Ferry free E39 –Fjord crossings Bjørnafjorden

Verification of AMC Floating Bridge Concepts BJF 2019

SBJ-32-C5-DNV-62-RE-025

Report No.: 2019-0299, Rev. 0

Figure 4-6 Abrupt end of longitudinal truss

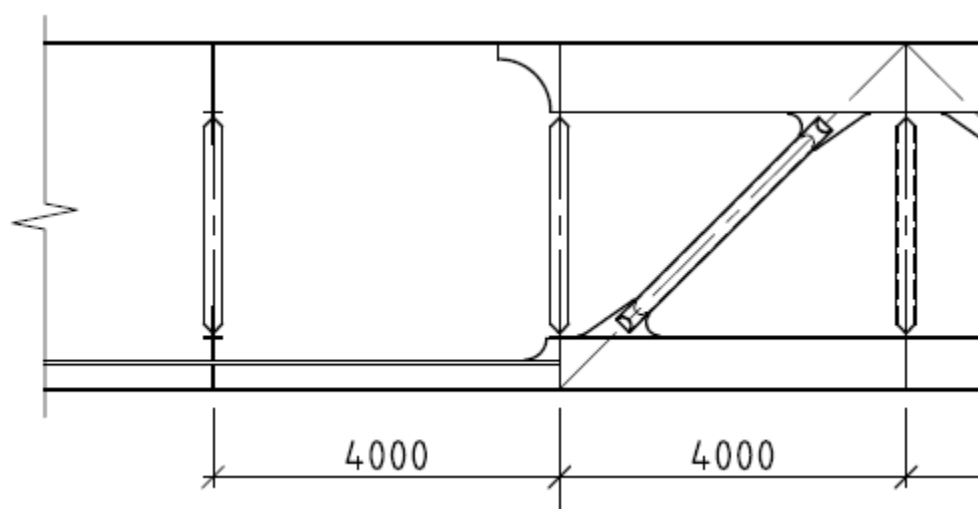
trusses there is an abrupt ending without a continuing stiffener as shown on **Figure 4-6**. This may be avoided in the next phase by careful distribution of the bridge deck stiffeners.

Figure 4-7 Location of hot spot used for assessment of detail type 2a and 2b. This is at the westerly wheel position in the westerly slow lane (From SBJ-32-C5-AMC-22-RE-109)

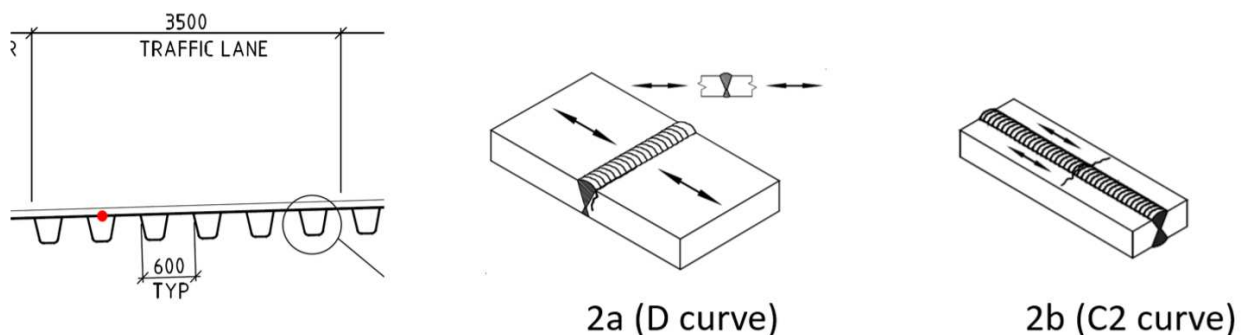
The fatigue of the transverse butt welds in the deck plate are assumed to be governing for determining the plate thickness for stress ranges in the longitudinal direction of the bridge from global and local load responses (detail 2a in Figure 4-7). A fabrication tolerance between the plates equal 2.0 mm is assumed as recommended in (Norwegian public roads adm, 2015). It is assumed that the design is performed using S-N curve D for double sided welds and that a misalignment equal $0.05t$ has been assumed included in this S-N curve which is according to the 2019 version of DNVGL-RP-C203. A Design Fatigue Factor equal 2.5 is used for the bridge girder.

It is noted that the calculated fatigue lives for butt welds type 2b (Figure 4-7) and trapezoidal longitudinal welds (Figure 4-9) do not meet the target life for local load effects. Reference is made to section 5.1.3 and 5.1.5 in Appendix I SBJ-32-C5-AMC-22-RE-109. This is a similar problem as observed with fatigue cracking through the deck plate as illustrated in Figure 4-10 in other suspension bridges which are described in recent published literature (Bohai, Rong, Ce, Hirofumi, & Xiangfai), (Cheng, Ye, Cao, Mbako, & Cao), (Kainuma, et al.), (Maljaars, Bonet, & Pijpers), (Yokozaki), (Wang) and (Zhu, et al.). According to Bohai et al. (2013) (Bohai, Rong, Ce, Hirofumi, & Xiangfai) it was found that one need to include the stiffness of the asphalt layer to get correspondence between observed fatigue cracking and calculated fatigue lives for fatigue cracking through the plate in a bridge girder with plate thickness 12 mm where fatigue cracking occurred only 5 years after being put in-service. Fatigue crack growth from the weld root through the deck plate in typical girders used in suspension bridges is now a large concern in many countries. Based on this experience it was decided to increase the deck plate thickness to 16 mm in the heavy truck lane in the Taizhou suspension bridge crossing the Yangtze River in China. This is

Figure 4-8 Location of hot spot used for assessment of detail type 5. This is at the westerly wheel position in the westerly slow lane (from SBJ-32-C5-AMC-22-RE-109)

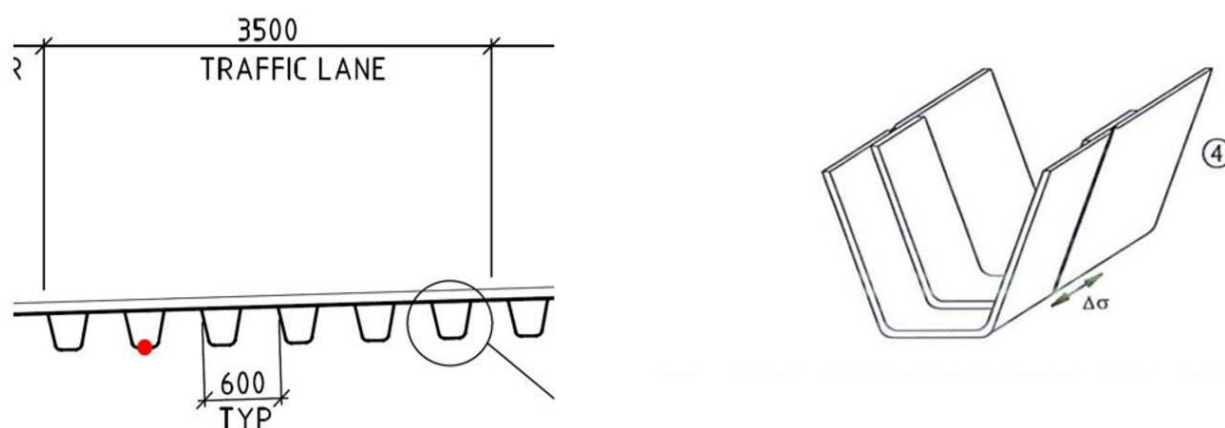
Reference is made to detail type 5 in section 5.1.6 of Appendix I SBJ-32-C5-AMC-22-RE-109 (Figure 4-8). It is noted that short fatigue lives are calculated for this detail due to global and local load effects. The reason for short calculated fatigue lives for this detail is bending of the stiffener due to wheel loads. It might be questioned if one should consider the stiffness effect of the asphalt layer as considered below for transverse stresses in the deck. However, it may be difficult to accept a stress reduction from global bending effects without including studs to document interaction between the asphalt layer and the deck plate for global beam loads. Another alternative may be to increase the stiffener size. The need for this depends also on the traffic model to be used. With the present traffic model, it is assessed that the target fatigue life can be achieved if the stiffeners areas below the heavy traffic lanes are increased by approximately 0.03 m².

Figure 4-11 Assembly of low floating bridge (from Figure 7-5 in Doc. No. SBJ-33-C5-AMC-28-RE-114, Appendix N, dated 15/8-19)

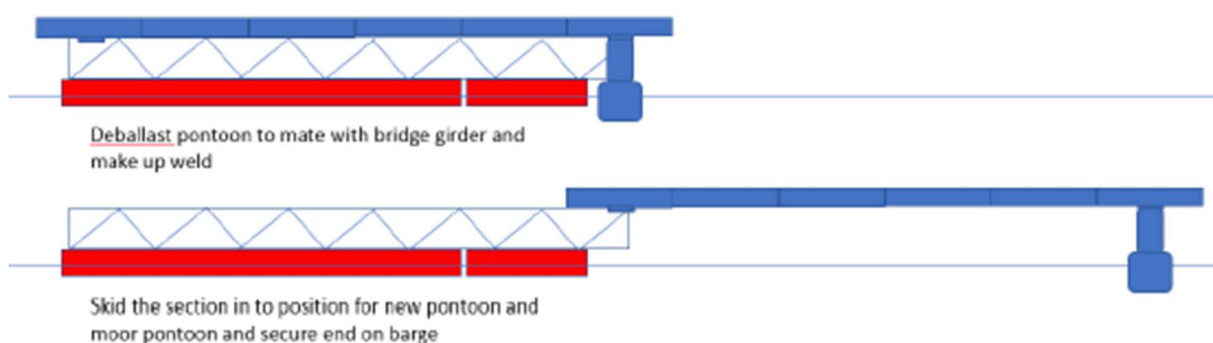
During assembly, the bridge girder will be skidded along the assembly platform. It is assumed that some form of load equalizing system is needed to have a distributed load along the bridge girder, hence avoiding large concentrated forces during skidding.

Further, unintended sliding of the bridge girder in an accidental condition during assembly or during skidding, refer to Figure 4-11, must be prevented.

Figure 4-12 Jacking of high bridge elements, (from Enclosure 2 in Doc. No. SBJ-33-C5-AMC-28-RE-114, Appendix N, dated 15/8-19)

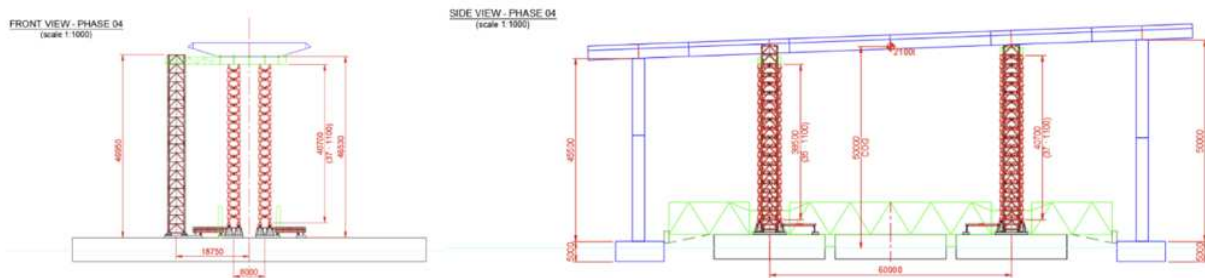
- Stability of the jacking towers in transverse direction is mentioned, and transverse support structures are indicated, see Figure 4-12. The longitudinal direction must also be considered in later phases, when relevant load cases have been defined.
- The 150m long bridge girder is supported by four jacking towers. A limited number of supports are indicated; hence a relatively large concentrated force is transferred into the bridge girders, and local reinforcements are required.

- The bridge girder must be kept in position on the jacking beams, i.e. prevented from sliding in case of severe heel or trim of the assembly platform. The supports are indicated to be low friction (teflon and stainless steel). The position keeping is assumed to be further detailed later.
- Stability of the assembly platform in accidental condition and the capacity of the stability masts needs to be checked in later phases.

Figure 4-14 Areas for assembly of high floating bridge (chart from www.norgeskart.no)

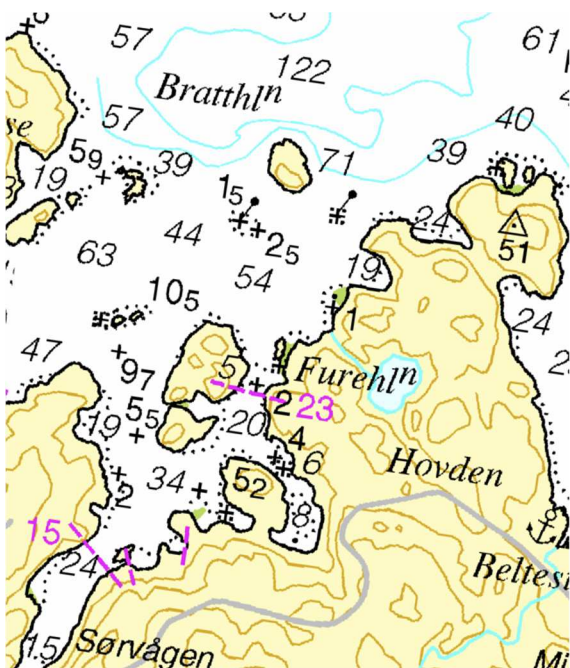
The water depth in the proposed area could also be a challenge for the proposed assembly site, see Figure 4-14.

Figure 4-15 Detail 6 from drawing SBJ-33-C5-AMC-22-DR-824, Rev. 0

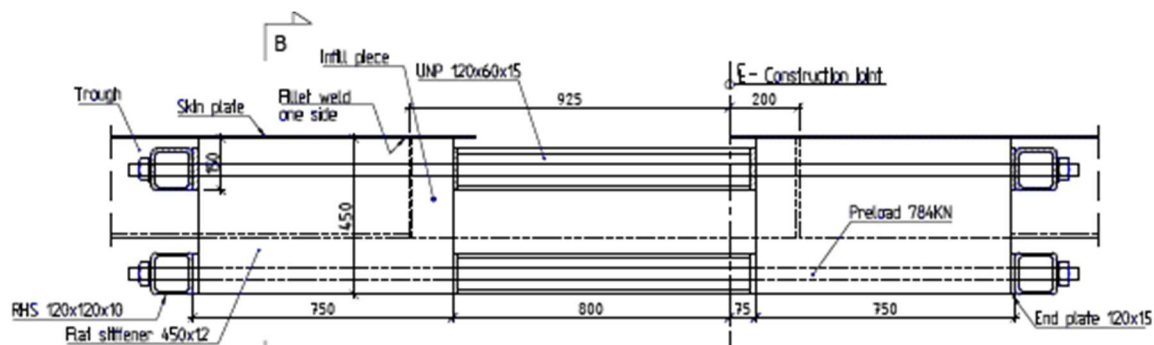
A few comments to the locking system shown in Figure 4-15:

- In the construction joints at the deck plate, infill pieces of the trapezoidal stiffeners (U-ribs) are indicated. It should be checked further how these infills can be fitted, as there seems to be a conflict with the bolts and the flat stiffeners 450x12.
- The eccentricity of the lower bolt from the deck plate needs to be accounted for. As a result of that, the indicated 750 mm long 450x12 stiffeners will probably have to be much longer.
- The RHS 120 x 10 profile seems weak for the actual bolt force

Ref. 10205546-13-RAP-166 Appendix K: Design of Floating Bridge Part. Appendix K – Enclosure 4 10205546-13-NOT-084 Shear lag and buckling effects of Bridge girder.

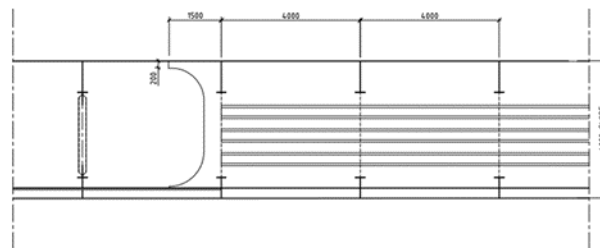
DNV GL: There are longitudinal panels at columns, but not at midspans. Detail of the ends of the panels to avoid stress concentrations?

AMC: The detail will be designed to avoid large stress concentrations.

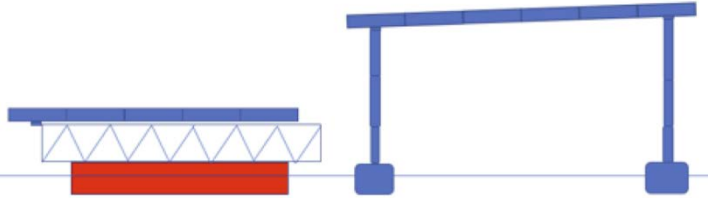
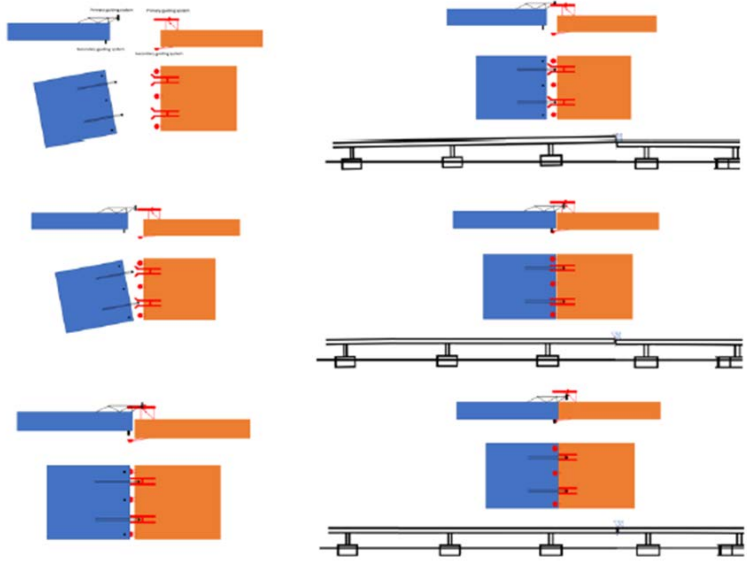
DNV GL: Has any additional cost of the castings been included in the cost estimate?

<p>AMC: Yes, extra cost will be evaluated, but by plan for casting in the beginning of the project the cost is marginal.</p>
<p>Design assumptions vs fabrication</p> 	<p>DNV GL: It is recommended to develop a fabrication specification to achieve the intended quality of fabrication that is in line with the design assumptions.</p> <p>AMC: We agree that this is required at a certain stage of the project</p> <p>DNV GL: The fatigue capacity is depending on the welding method and welding position. Selection of S-N curve D means welding between plates in the horizontal position. Thus, it is assumed that the plates between thickness transitions are welded in this position.</p> <p>AMC: Yes</p> <p>DNV GL: Will welding at site between sections be made against backing?</p> <p>AMC: Yes</p> <p>DNV GL: Welding of bulbs?</p> <p>AMC: Full penetration weld</p> <p>DNV GL: Based on experience with fabrication of other highly utilised structures with respect to fatigue, such as support structures for wind turbines, it is observed that the as-built tolerances are typical close to that allowable in the fabrication standards.</p> <p>AMC: Standard fabrication is assumed, supplementary specifications as required to be developed during engineering</p> <p>DNV GL: Based on experience it is also observed that the reliability of standard inspection methods for detection of internal defects such as manual UT is low.</p> <p>AMC: Noted, should be addressed in later phases</p> <p>DNV GL: In a project with long welds it is recommended to develop separate tools for detection of defects during fabrication (in shop and on site).</p> <p>AMC: Noted, should be addressed in later phases</p>
